Intel® Server Board SHG2

Specification Update

Intel Order Number: C20107-002

January 2003

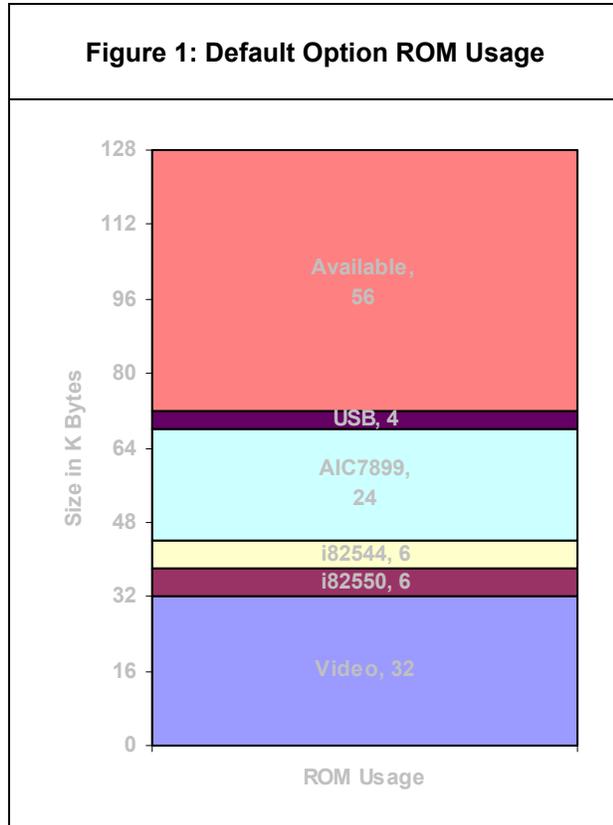
Implication: The amount of space reserved by the system for Option ROMs is limited to 128K on SHG2 based systems. This space is shared by the on-board device option ROMs and any add-in adapter option ROMs. The on-board devices are: video, gigabit NIC, 10/100 NIC, SCSI controller, and USB. All of the on-board option ROMs are enabled by default with the exception of USB.

When all of the on-board option ROMs are loaded at boot time, there is a reduced amount of reserved space left for add-in adapter card option ROMs to expand and load (see *Figure 1*). If enough space does not exist for a particular adapter, that adapter's option ROM will fail to expand and will post an error message during system boot.

For example, assume *Adapter A's* (a SCSI adapter) option ROM requests 64K of initial memory and then reduces the final amount of memory used to 32K. In the example in *Figure 1*, the *Adapter A's* option ROM expansion would fail because the initial request for memory was 64K while 56K is available.

In order to enable Adapter A's option ROM to load, adjustments need to be made to the option ROM usage area. Since Adapter A is a SCSI adapter, in this example it is determined that the on-board 7899 SCSI controller option ROM can be disabled because it is not going to be utilized as a boot device. By disabling the on-board 7899 option ROM, 24KB of space is release giving a total of 80KB. In this configuration Adapter A will pass the initial request of 64KB space, reduce to 32KB, and will successfully load leaving a memory usage map similar to that shown in Figure 2.
